CORPS OF ENGINEERS BUFFALO NY BUFFALO DISTRICT
BIG CREEK FLOOD CONTROL PROJECT, CLEVELAND, OHIO. PHASE II. GEN--ETC(U)
AUG 79

CLEVELAND, OHIO

GENERAL DESIGN MEMORANDUM

AUGUST 1979

BIG CREEK WATERSHED
CLEVELAND, OHIO
FLOODWAY
LOW FLOW CHANNEL
CROSS SECTION
U.S. ARMY ENGINEER DISTRICT BUFFALO

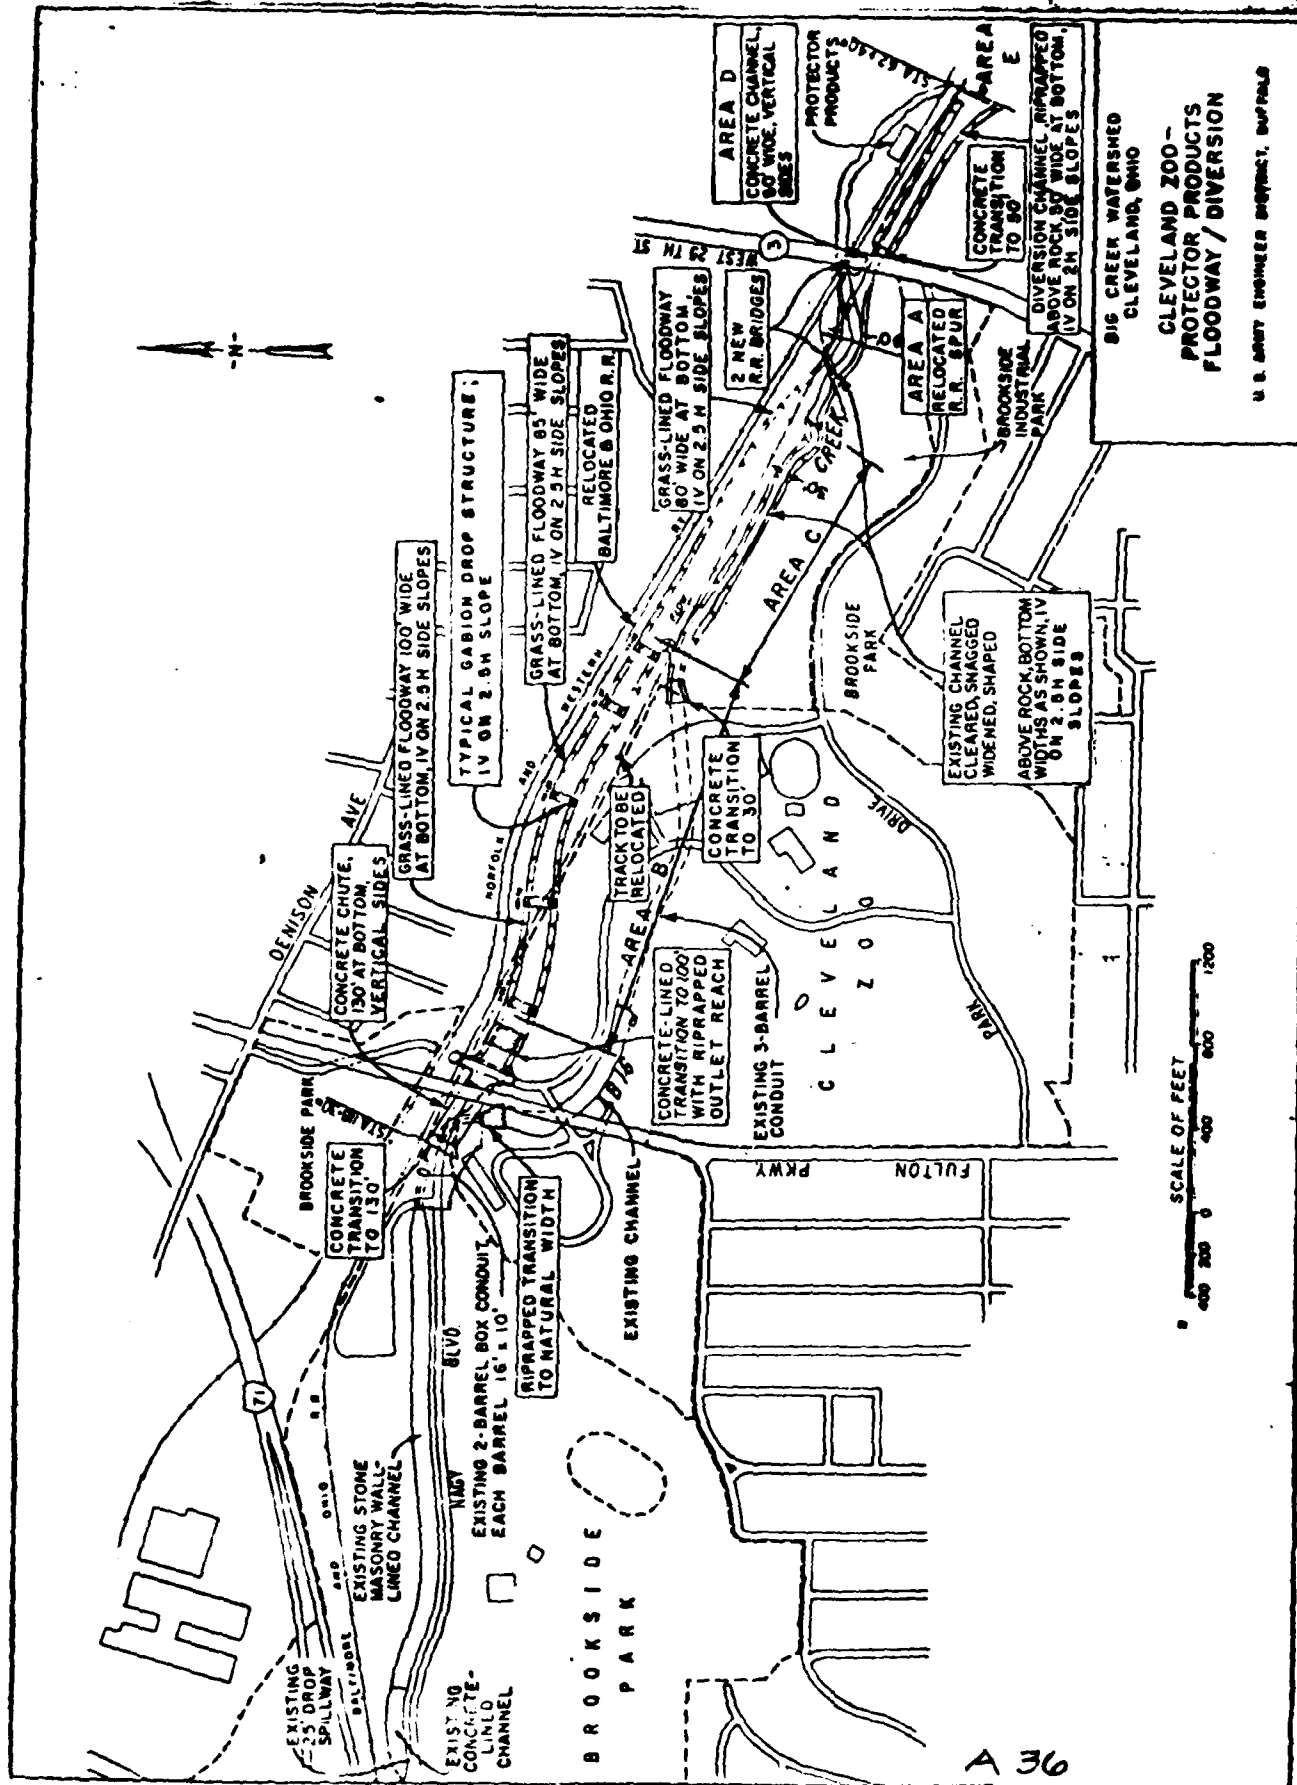
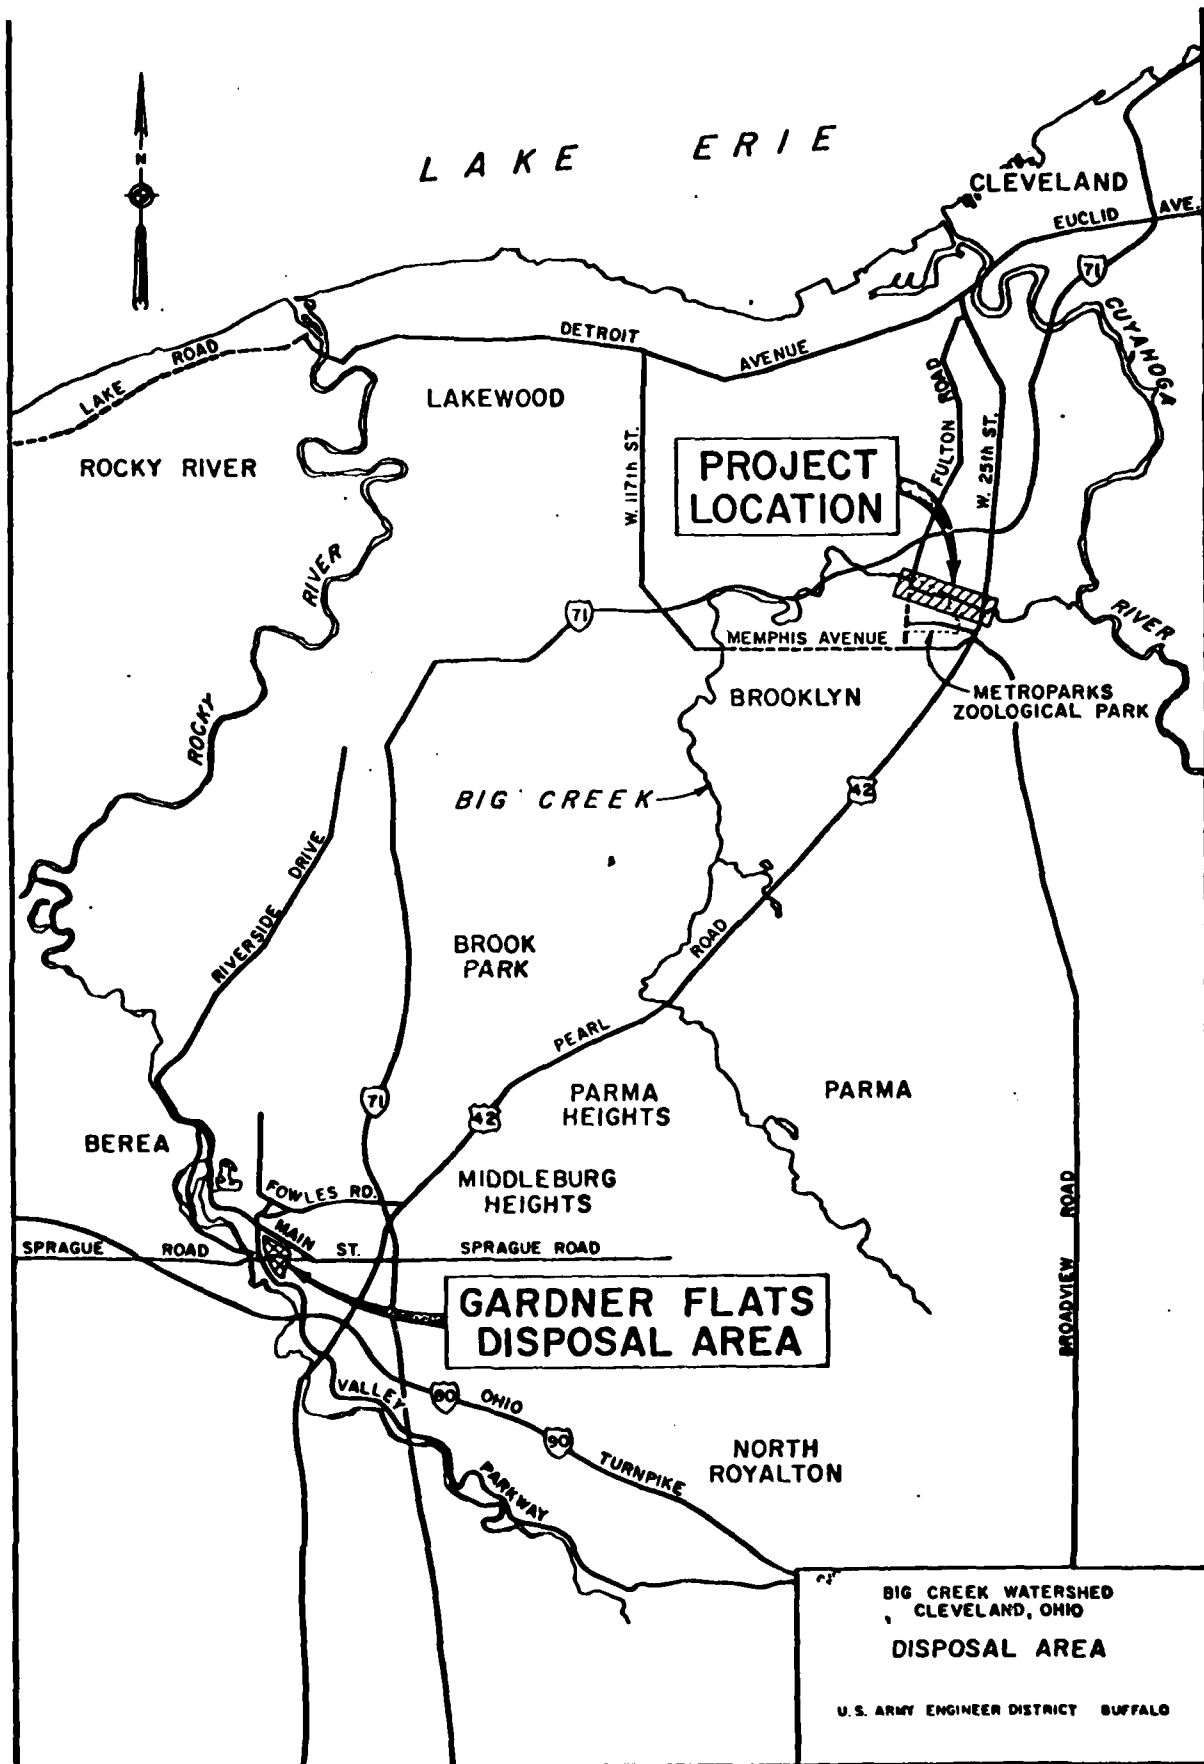
c. Elimination of the Levee Structure Between the Floodway and Natural Creek (see Area "C" on Plates 1 and 2). The Phase I GDM design included a levee between 1,470 linear feet of parallel creek and floodway channels. This design feature has been revised to eliminate the levee, thereby combining the floodway and original channel

in the cross section configuration, including low-flow channel, as illustrated in Figure 1. The levee was found unfeasible when design refinements revealed that areal restrictions decreased the area available to the levee, reducing it to a floodwall. The purpose of the levee was to maximize the length of the 30-foot wide natural creek channel before its confluence with the floodway. However, reducing the levee to a floodwall would partially defeat the purpose of the levee since it would be aesthetically unnatural and unappealing as well as very expensive. The 30-foot wide low-flow channel within the combined channel-floodway is a feasible alternative which will minimize impacts to the natural environment, and while unnatural, will be more appealing than the feasible floodwall alternative.

PLATE C14

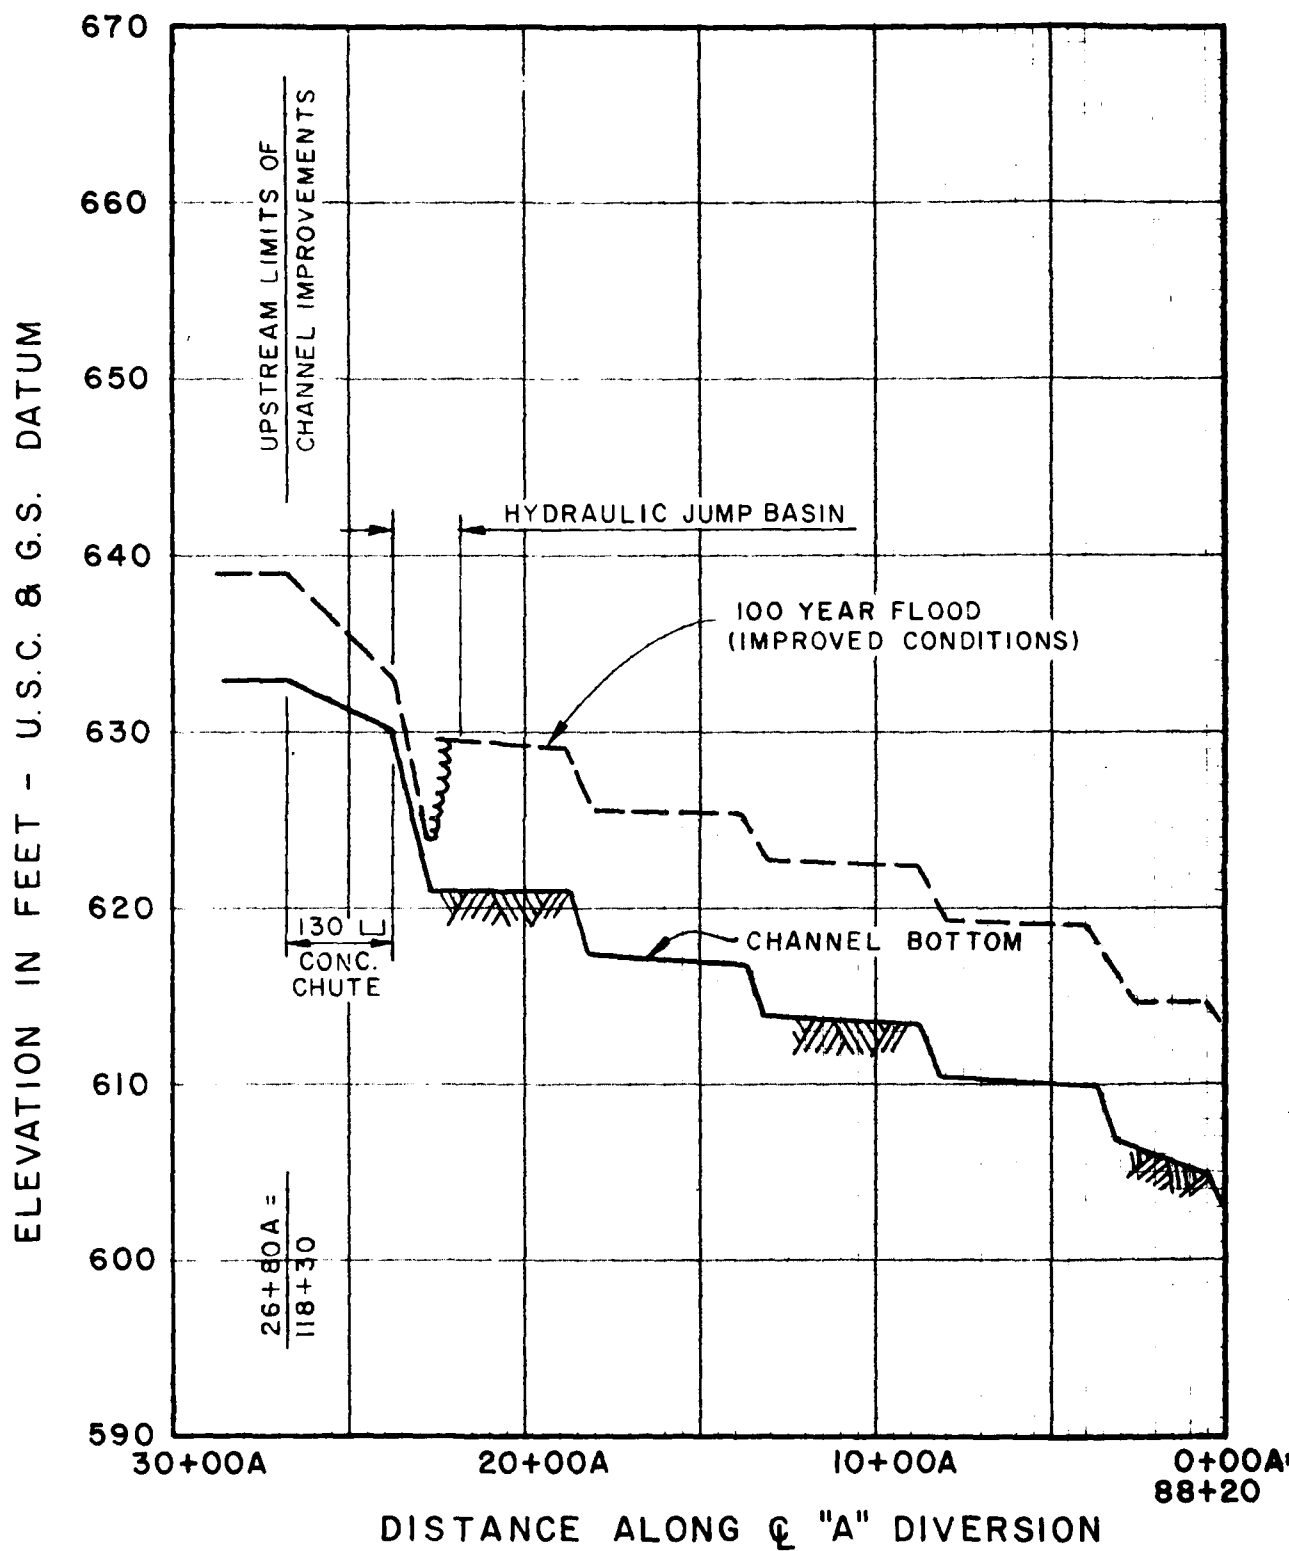
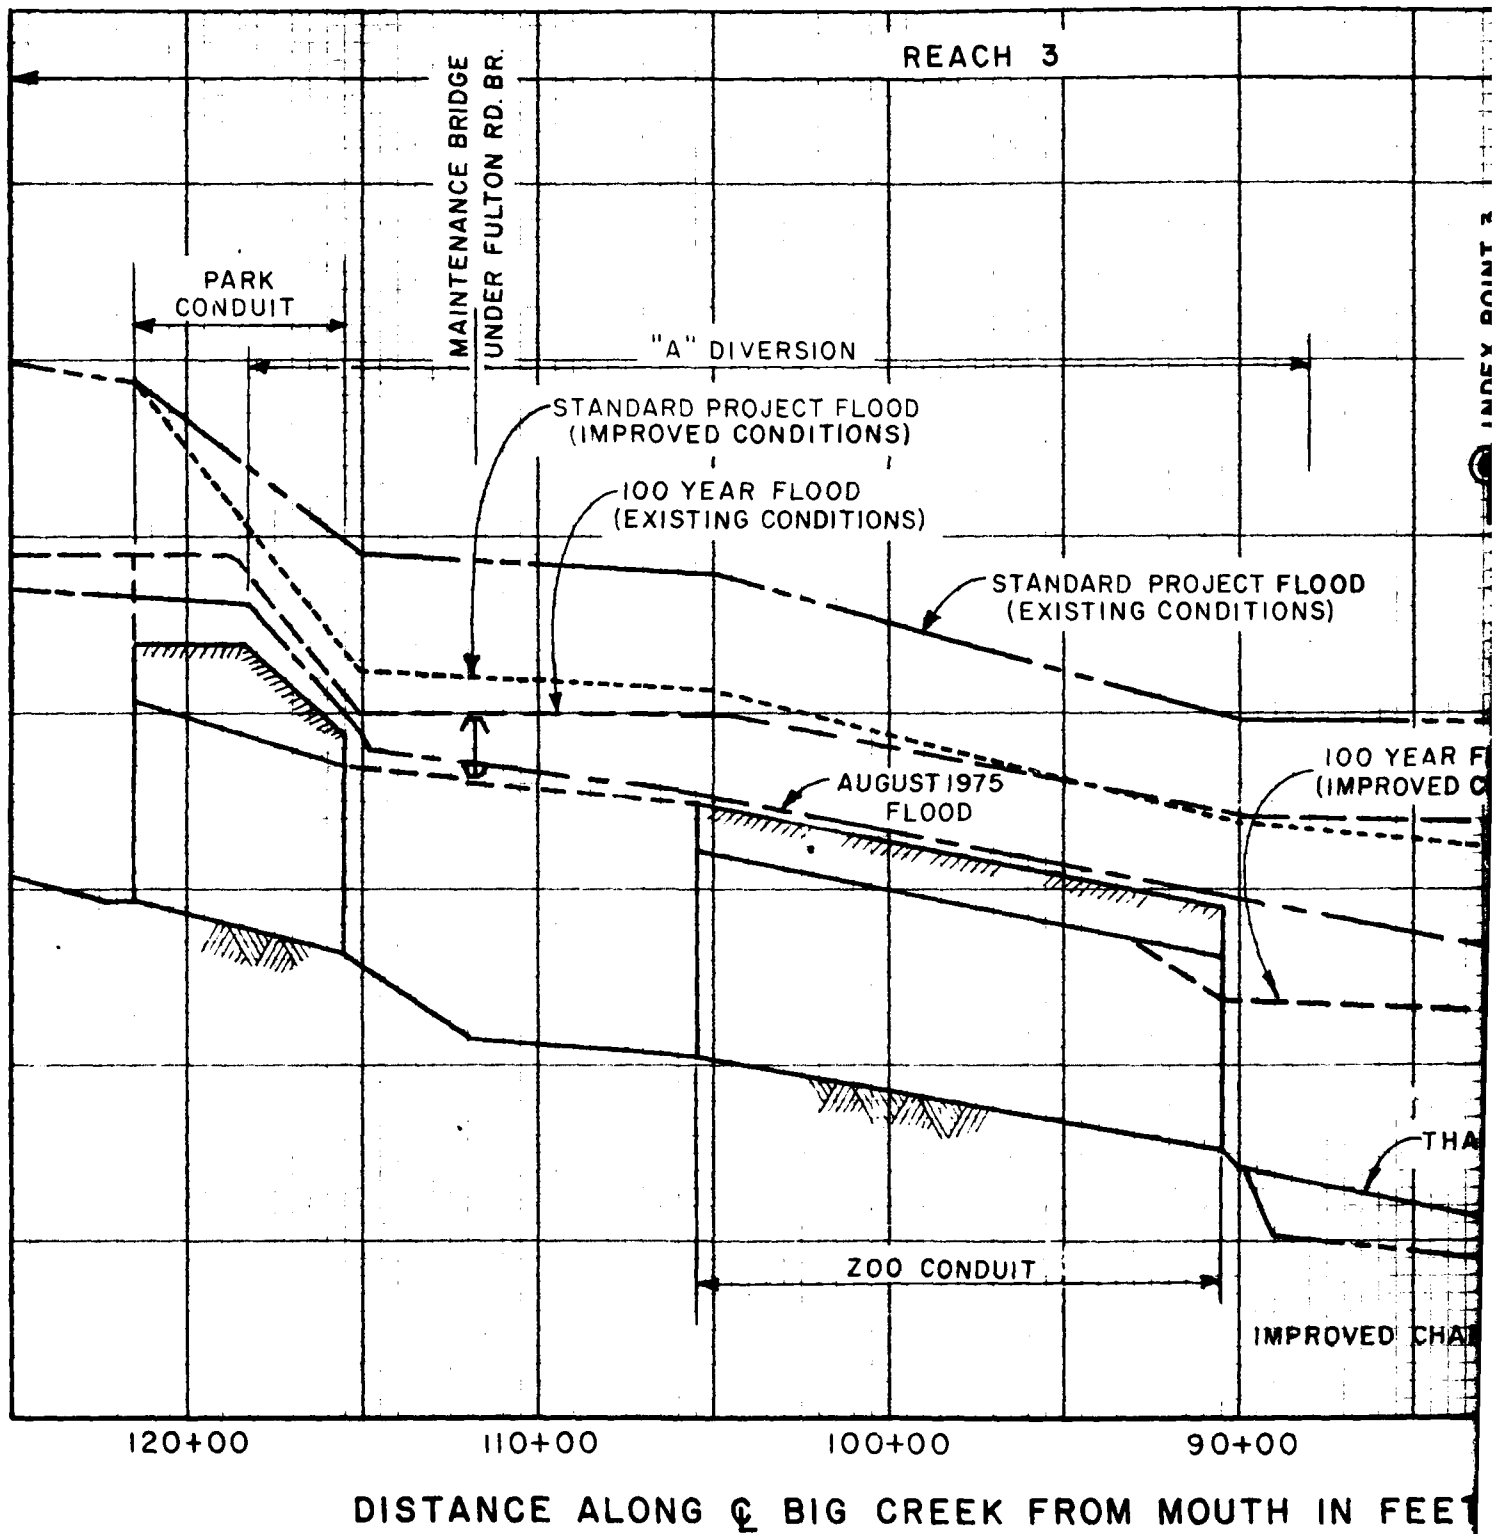
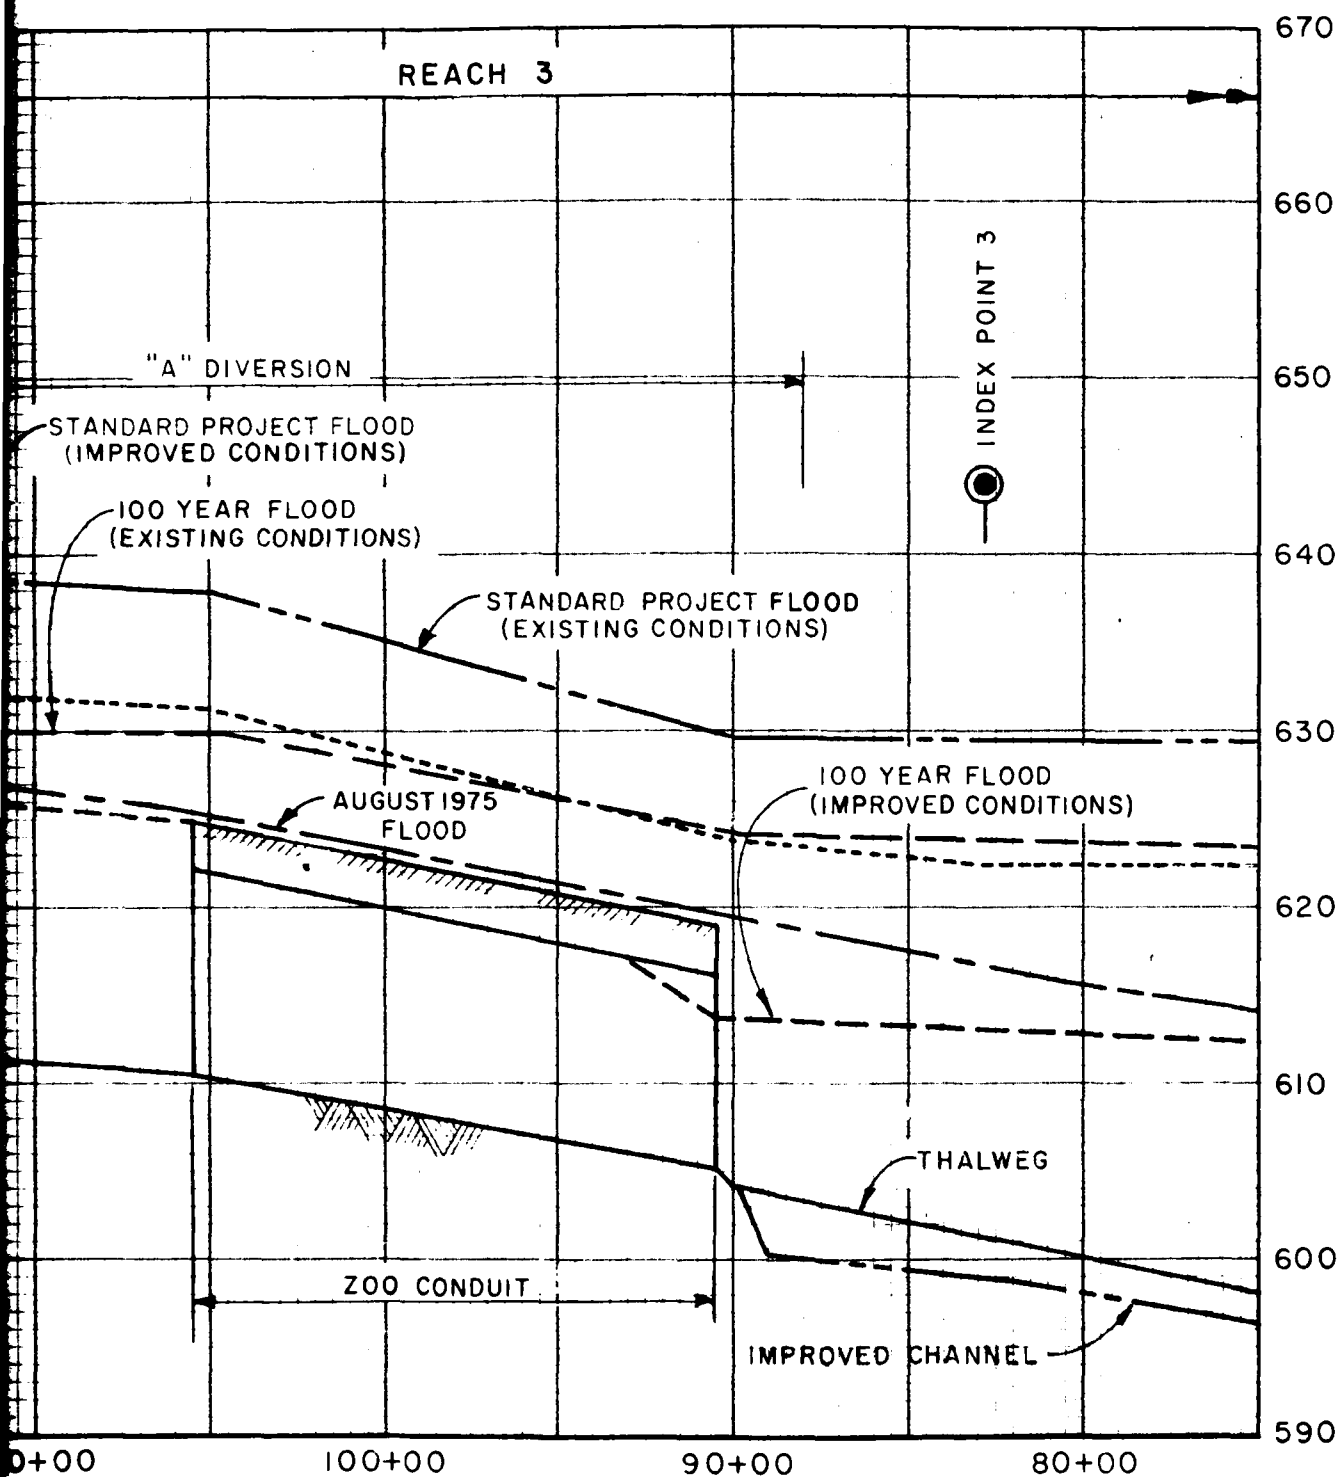
b. Plate C-15. The water surface profile along the "A" Diversion is unrealistic. The correct computer profile should be plotted and should approximate an M-2 profile since the control is near the drop for each step and the water surface appears to approach normal depth in the upstream direction in a channel having a mild slope.

m. Comment 12(b). Critical flow depths exist at all drops. The flow profiles next to these drops resemble the profiles near constricted flow openings. The flow profiles reach normal depth a short distance from the drop and were plotted from the back-water computation results. The scale on page C-15 is such that the profiles appear to be straight lines. Further, there is no significant effect of the water surface elevation near these drops based on the area around the floodway.
